NTD-NRC-94-4237
DCP/NRC0163
Docket No.: STN-52-003

SUBJECT: WESTINGHOUSE RESPONSES TO NRC REQUESTS FOR ADDITIONAL
INFORMATION ON THE AP600

NTD-NRC-94-4237
ATTACHMENT A
AP600 RAI RESPONSES
SUBMITTED JULY 27, 1994

Figure 230.59-1 - Relationships between Maximum Component Responses for X, Y, Z

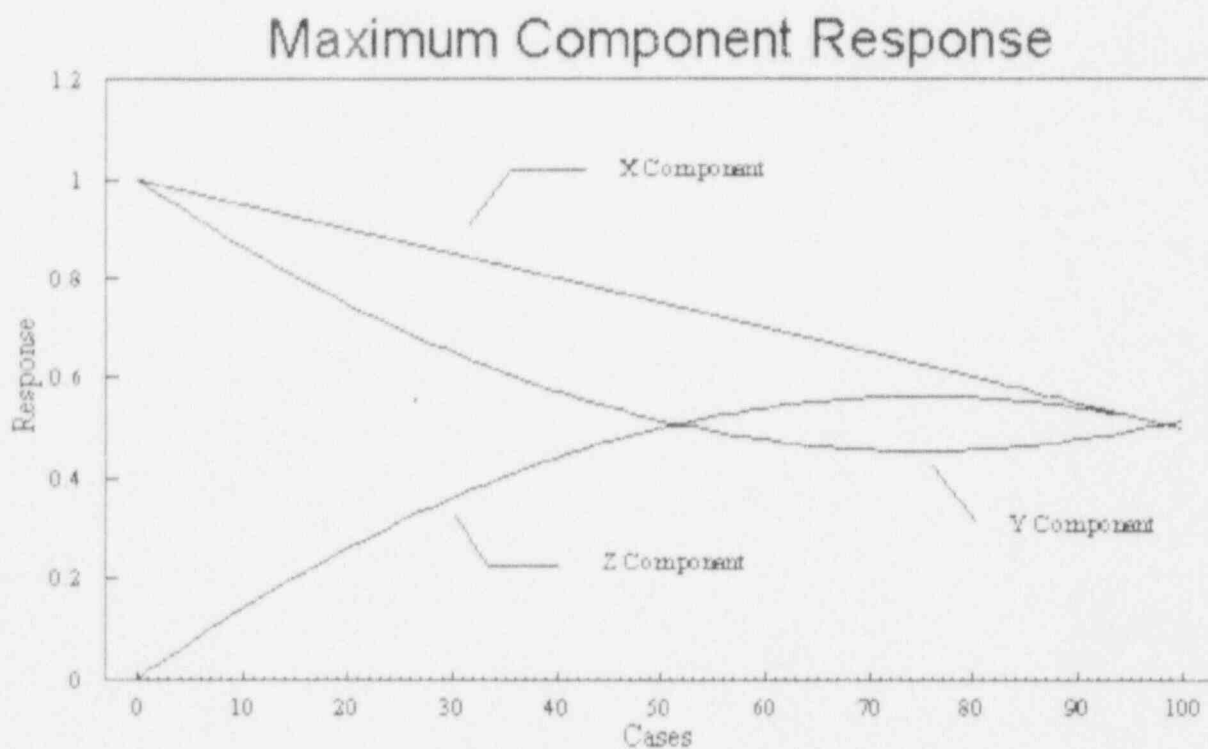
Provide, in the SSAR, a comparison between the SRSS method and the 1.0, 0.4, 0.4 method, or the bases for use of only the 1.0, 0.4, 0.4 method for the combination of seismic loads. Also Q220.67.

A representative set of co-directional responses are assumed having different relationships between these responses. Figure 230.59-1 shows these relationships for each of one hundred cases. The co-directional response for the X shock, Y shock, and Z shock have all been normalized by the maximum response. There are various cases that include two of the components of equal magnitude, three of equal magnitude, and many cases in between with one component being dominant. Figure 230.59-2 shows the formulation and results of SRSS and 40% combination methods. In only one case does the 40% combination method yield results that are lower (only 1%, 1.414 versus 1.4) than the SRSS method. This is when two of the components are equal, and the other is zero.
